GROUP 16

ENGINE ELECTRICAL

IGNITION SYSTEM

OUTLINE OF CHANGES

GENERAL INFORMATION

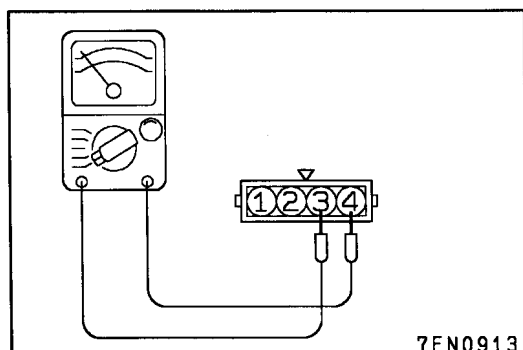
The 4G93-GDI engine has been replaced with the 4G94-GDI engine. Due to this, the following service adjustment procedures have been changed. Other procedures are the same as the conventional 4G93-GDI engine.

- An ignition failure sensor has been added.
- The spark plug type has been changed.

Items	Specifications
NGK	IZFR5B

IGNITION FAILURE SENSOR CHECK

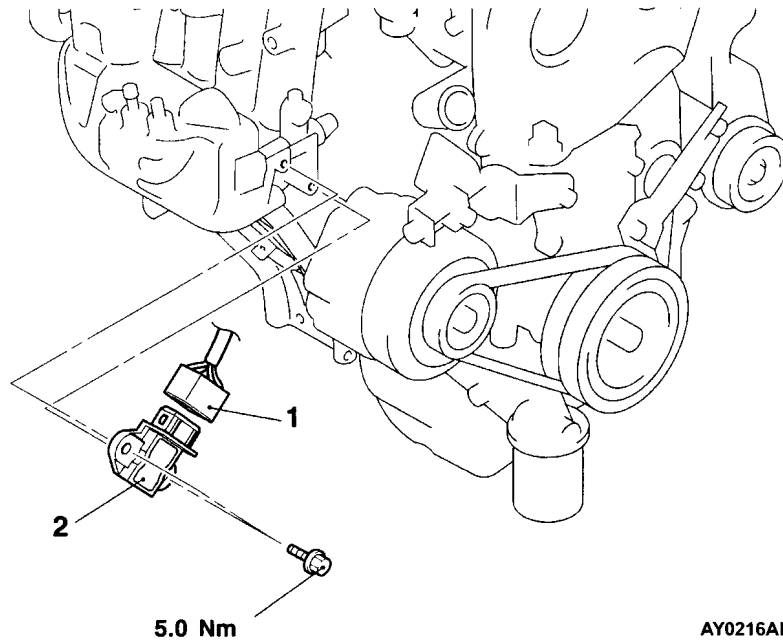
Check that the resistance between terminals 3 and 4 is at the standard value.

Standard value: 0.1 Ω or less
